Blackpool Council

PLANNING COMMITTEE

Planning Application Reports – Update Notes

Case: Year:	Address:	Update:
16/0473	585-593 Promenade and 1 Wimbourne Place	<p>Additional representations have been received from –</p> <p>Mr Hyatt, 32 Clifton Drive, Blackpool – Here are further objections, based on the amended site layout documents (ref: 16/0473) posted on the Council Planning website on 12 October.</p> <p>Some changes have been made to the car park area.</p> <p>1. There is a note saying 'right of way for garages' at the north end of the car park but there is no indication of where this runs. I've taken the liberty of marking the footpath (to which this note refers) on the attached site layout plan (document attached). I've followed the line of the path as shown on Land Registry documents already supplied to Council Planning staff. I've also indicated where a Blackpool Council street light is positioned on the pathway.</p> <p>The path is approx 6 feet wide where it currently runs behind the Kingsbury, Alderney and Ocean Bay hotels (before passing behind the Kimberley).</p> <p>I don't think this is 'right of way for garages' as stated. It appears to be a general right of way to th

Site Plan
Waldorf Hotel, New South Promenade, Blackpool.

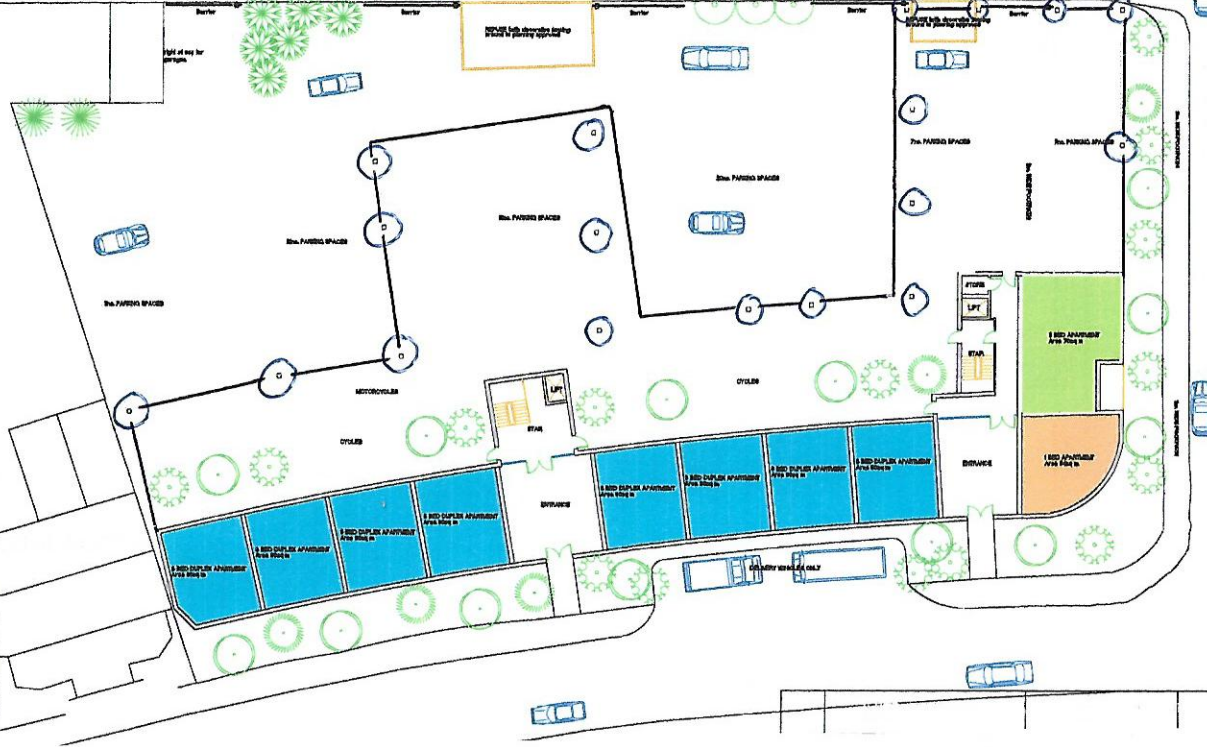
Query on distance between end of block and rear boundary walls of houses on Clifton Drive (appears to be width of back alley which is approx 5.3 metres).

Amended site layout showing outline of proposed building with supporting columns ringed. Please compare with the 'sketch to rear of proposed flats' to see differences.
